Subject: Attn. Development Assessment - DA2022/1128 Objection Letter Re. 38

The Drive, Freshwater.

DA2022/1128 - 38 The Drive, Freshwater.

Objection Letter from Scott Miner, Architect for the owners of 36 the Drive, Freshwater.

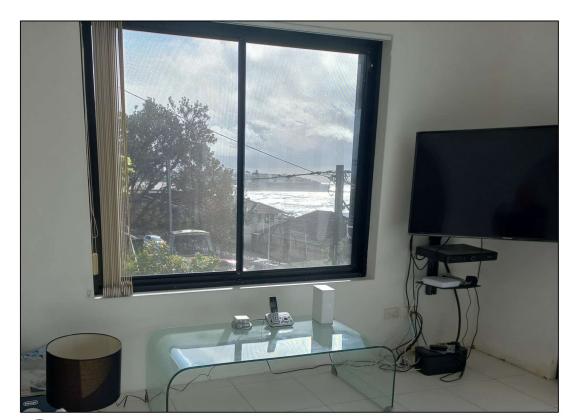
Whilst we welcome the increased setback to the First Floor Sitting Room glazing line and the attempt to introduce some planting, the height above natural ground

- and the proximity of the Bed 5 & Living Room glazing to the boundary of 36 The Drive is unacceptable.
- We note that the extent of elevated bedroom and living room windows directly overlooking the rear yard of 36 The Drive is even more evident with the removal of the external vertical screens.

- The floor of Bedroom 5 (RL 47.33) is approx 1.8m above the natural ground level. A 1.8m high boundary fence will not prevent total overlooking of 36 The Drive's property.

- The floor of the Entertaining Area on Level 1 (RL50.80) is approx 2.8m above natural ground level at the boundary, 1m away from the window glazing. Boundary Fencing will not prevent total overlooking of 36 The Drive and no external privacy screens are proposed.

OBJ-05

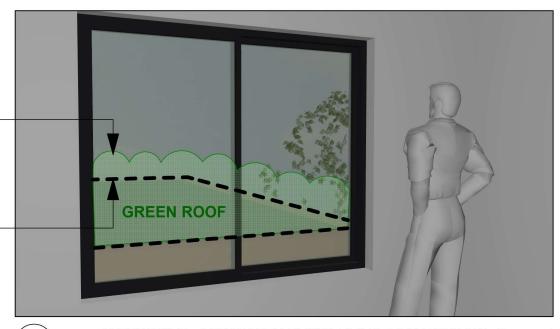
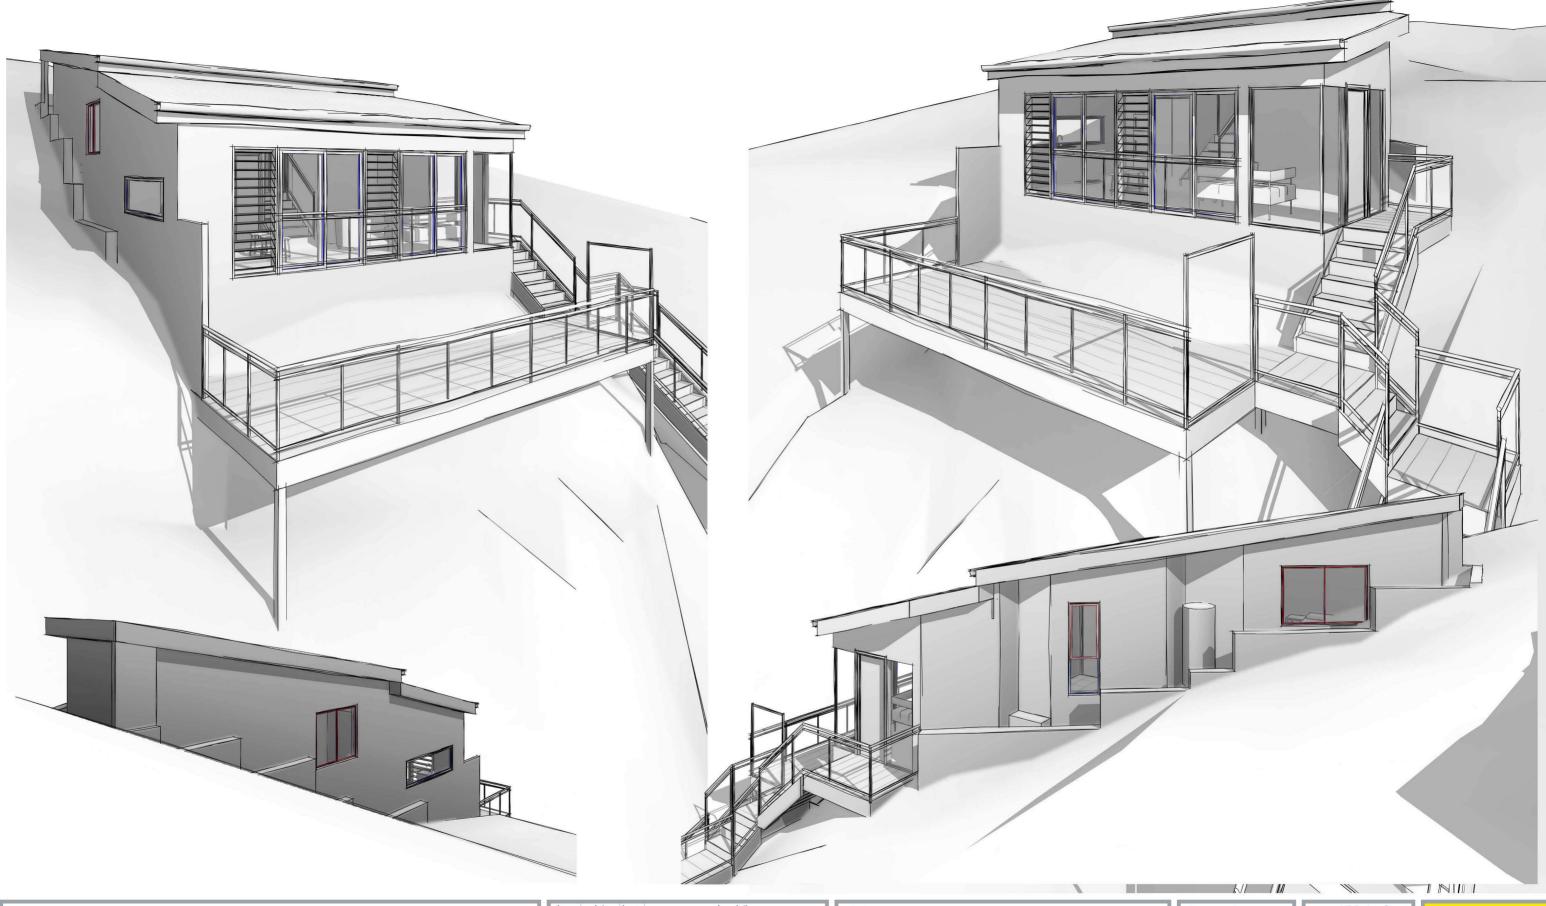
The Green Roof above the Secondary Dwelling is another point of objection. Whilst we welcome the lowering of the Secondary Dwelling roof height to preserve #36's existing views across the site to the beach, headland and ocean beyond, we worry that rooftop planting will quickly grow and block these established Northerly views. If council cannot condition a permanent height of green roof landscaping, we ask that the roof be changed to a medium to dark coloured roof, or concrete roof with pebble ballast would be preferred. If a green roof with soil and landscaping is to be approved, even moderate sized planting will cause substantial view loss from the only North-facing Living Room window. Without a view-loss diagram prepared by the applicant, we have prepared a diagram that attempts to illustrate the potential view loss from the secondary dwelling rooftop planting. OBJ-05 38 The Drive 2023 DA Objection Diagram.pdf

PROPOSED SECONDARY **DWELLING ROOF** PARAPET RL31.45. DOTTED LINE COPIED FROM CAD IMAGE BELOW.

CONCERN OVER VIEW LOSS FROM LANDSCAPING AND **PLANTS GROWING ON** THE PROPOSED GREEN ROOF TOP.

A pebble ballast concrete roof or non-reflective metal roof would ensure Northerly ocean views are not lost over time from #36

PROPOSED SECONDARY DWELLING ROOF PARAPET RL31.45. DOTTED PARAPET EDGE MODELLED IN CAD.
